# Access Compliance Report

## Public Rights-of-Way

### (Curb Ramps)

Intersection ID: 10023487	Main Street: CIRCUMFERENTIAL_RD	Cross Street: N/A	Location: E
ADA ID: A4A58EF4E87A	Ramp Type: Perp	Initial Pass/Fail: Fail	Overall Compliance: No
Severity Score: 21.25			
Codes/Mitigation Info/Possible Solution		Field Measurements/Component Compliance

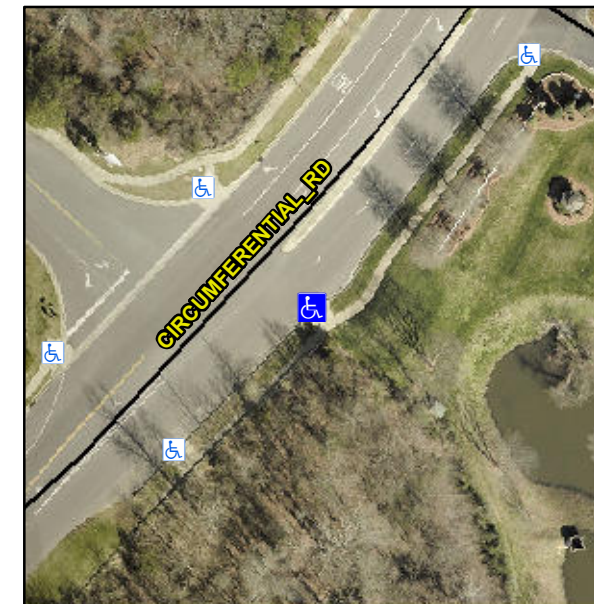
**Not Found, R304.5.1, R304.5.3**

Compliance	Description	Data	Compliance	Description	Data
N/A	Ramp Length (in)	102.0	Yes	Ramp Slope (%)	6.4
No	Ramp Width (in)	47.5	No	Ramp XSlope (%)	5.6
N/A	Flare Type LT	N/A	N/A	Flare Type RT	N/A
N/A	Flare Slope LT (%)	N/A	N/A	Flare Slope RT (%)	N/A
N/A	Flare Traversable LT?	N/A	N/A	Flare Traversable RT?	N/A
N/A	Landing Length (in)	N/A	N/A	DWS Provided?	N/A
N/A	Landing Width (in)	N/A	N/A	DWS Contrast?	N/A
N/A	Landing Slope (%)	N/A	N/A	DWS Length (in)	N/A
N/A	Landing X Slope (%)	N/A	N/A	DWS Full Width?	N/A
N/A	Landing Curb? (Y/N)	N/A	N/A	DWS Offset (in)	N/A
N/A	Shared Landing?	N/A			
N/A	Gutter Ponding?	N/A	N/A	Gutter Slope (%)	N/A
N/A	Gutter Lip Ht (in)	N/A	N/A	Gutter X Slope (%)	N/A
N/A	Painted X Walk1?	No	N/A	Painted X Walk2?	N/A
	X Walk 1 Direction	To NW		X Walk 2 Direction	N/A
N/A	X Walk 1 Width (in)	N/A	N/A	X Walk 2 Width (in)	N/A
	X Walk 1 Slope (%)	0.4		X Walk 2 Slope (%)	N/A
	X Walk 1 X Slope (%)	2.5		X Walk 2 X Slope (%)	N/A

**Remove & Replace Entire Ramp.**
